RAI 03.07.02-24, Supplement 1, Revision 1**QUESTION:****Follow-up Question to RAI 03.07.02-15 (STP-NRC-100036)**

RAI 03.08.01-9, Revision 2**QUESTION:****Follow-up to Question 03.08.01-6**

RAI 03.08.04-17, Supplement 1**QUESTION:****Follow-up to Question 03.08.04-1 (RAI 2964)**

RAI 03.08.04-28, Revision 1**QUESTION:****Follow-up to Question 03.08.04-19**

**Figure 3H.6-209: SSI Model of RSW Piping Tunnel**

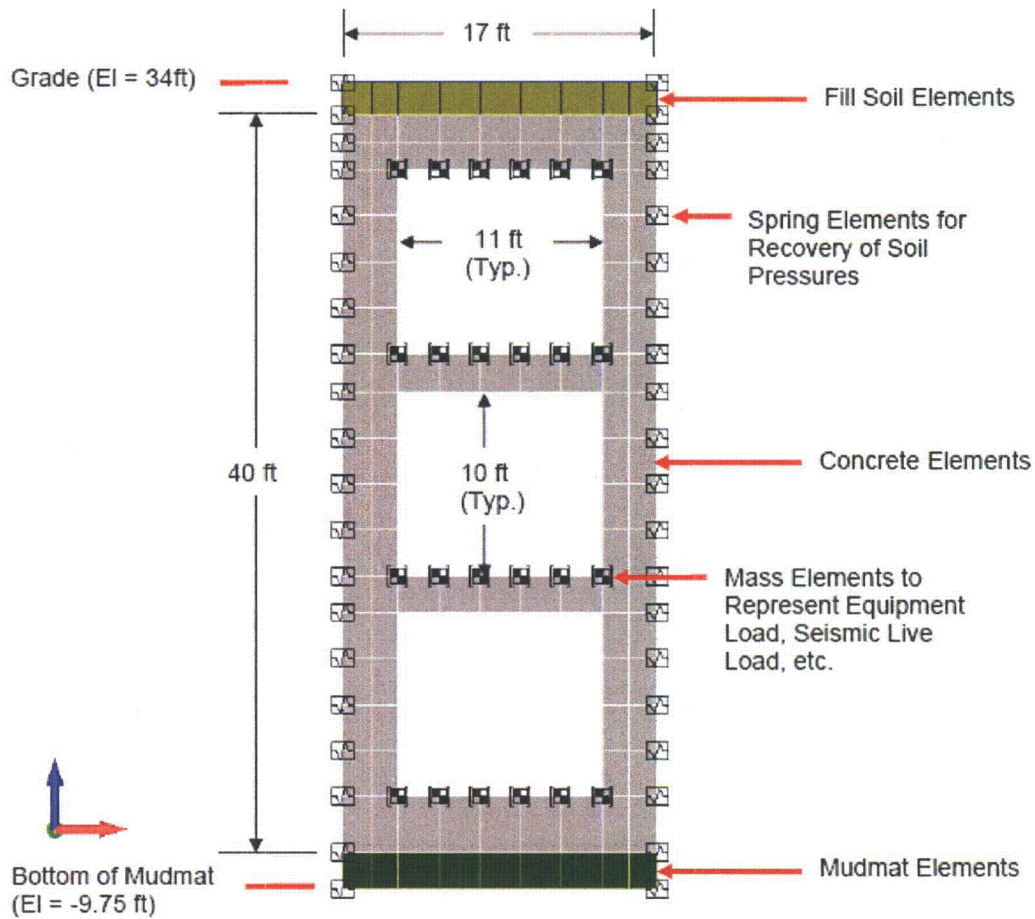
1. In the response to Item 1 of RAI 03.07.02-15, the applicant has stated that a 2D SSI analysis of the RSW tunnel has been performed to quantify the in-structure response of the tunnel. No details of this analysis have been provided. As such, the applicant is requested to describe in sufficient detail in the FSAR how the SSI analysis of the RSW tunnel has been performed. The description shall include the SSI methodology, figures showing the SSI model and boundary conditions, summary of the soil and structure properties, the input motion, etc. so the review can be completed.

Figure 3H.6-209 (all referenced figures and tables are included with COLA mark-ups in Enclosure 1) shows the structural part of the 2D plane-strain model of the reinforced concrete RSW Piping Tunnel with 2 ft thick mud mat under the base slab. The top of the Tunnel is 1.75 ft below grade. The model uses 4-node plane-strain elements to model the 3 ft thick exterior walls, 3 ft thick base slab, two 2 ft thick intermediate floors, 2 ft thick mud mat and the 1.75 ft soil above the Tunnel. As shown in Figure 3H.6-209, spring elements are added on the side walls of the Tunnel to calculate the seismic soil pressures on the Tunnel walls.

Figure 3H.6-209 shows the structural part of the 2D plane-strain model of the reinforced concrete RSW Piping Tunnel with 2 ft thick mud mat under the base slab. The top of the tunnel is 1.75 ft below grade. The model uses 4-node plane-strain elements to model the 3 ft thick exterior walls, 3 ft thick base slab, two 2 ft thick intermediate floors, 2 ft

Figure 3H.6-210: SSSI 2D Model of RB + RSW Piping Tunnel + RWB

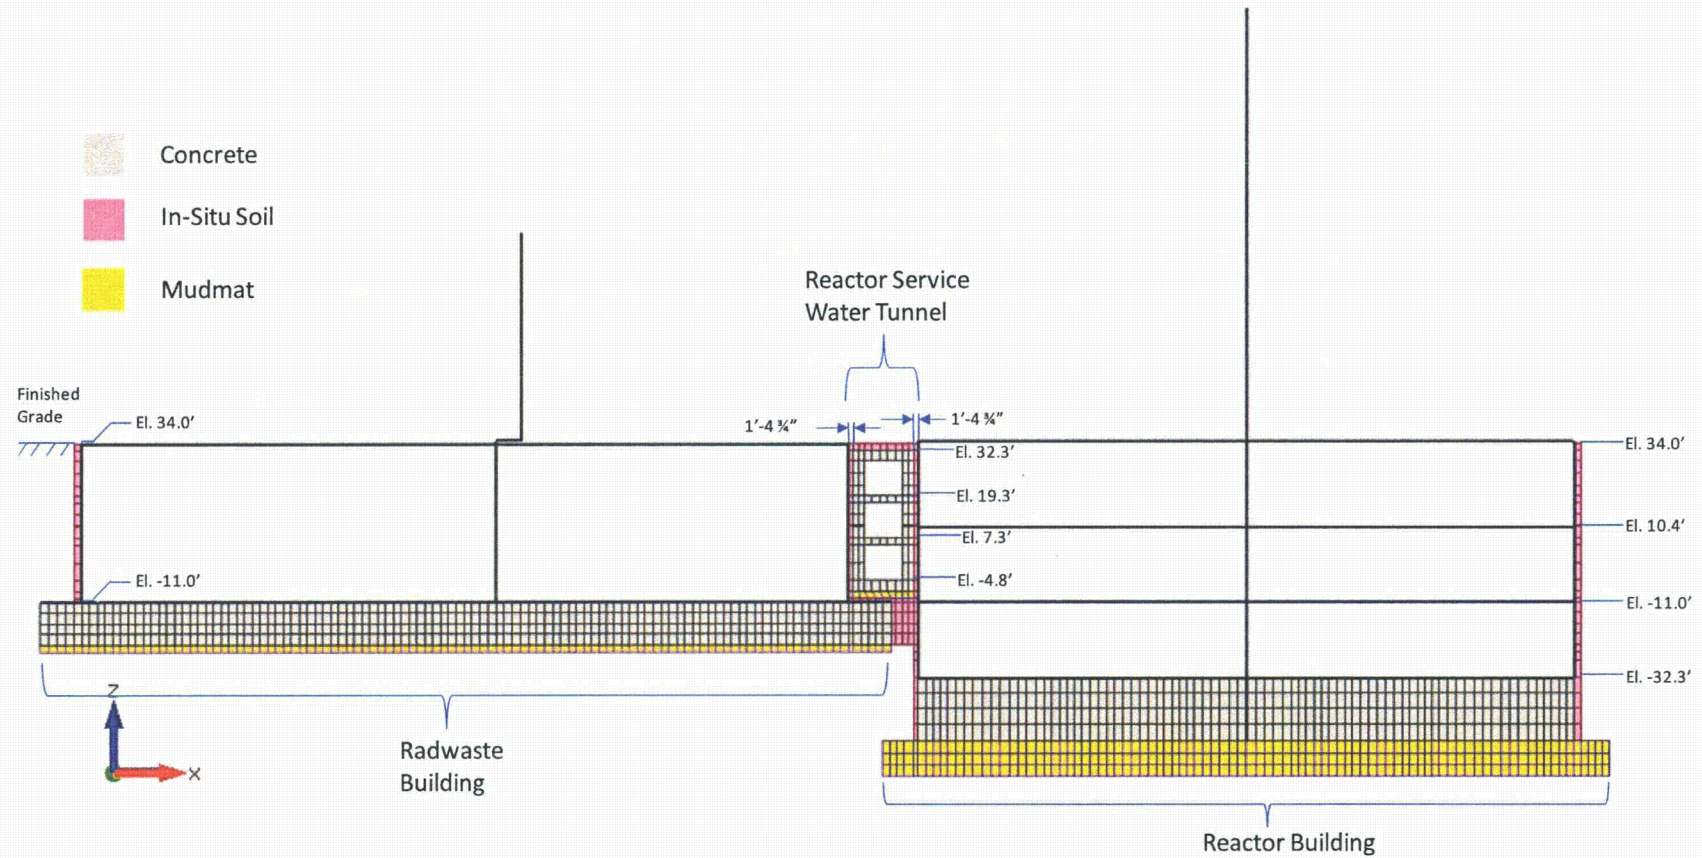
2. In the response to Item 2 of RAI 03.07.02-15, the applicant has stated that simple manual calculations were used for the analysis and design of individual components of the RSW piping tunnel. For this analysis, the tunnel walls, slabs and base mat are considered as rigid elements, and seismic loads are calculated based on a ZPA of 0.21g. The applicant further states that the analysis did not include any model or soil springs; the seismic loads are applied in terms of dynamic soil pressures on the exterior walls, calculated as per ASCE 4-98 recommendations. Staff has not endorsed ASCE 4-98 recommended dynamic soil pressures for design of tunnel walls. As such, the applicant is requested to provide comparisons of the dynamic soil pressures on the RSW tunnel walls calculated using 2D SSI model versus those of ASCE 4-98 to demonstrate that the design pressures are still bounding when the effects of kinematic interaction between tunnel structures and surrounding soils as well as the effects of structure-soil-structure interaction (SSSI) due to nearby heavy structures are considered.

Figure 3H.6-210 shows the structural part of the 2D plane-strain model of RB + RSW Piping Tunnel + RWB. Specifics of this SSSI analysis are as follows:

Figure 3H.6-210 shows the structural part of the 2D plane-strain model of RB + RSW Piping Tunnel + RWB. Specifics of this SSSI analysis are as follows:
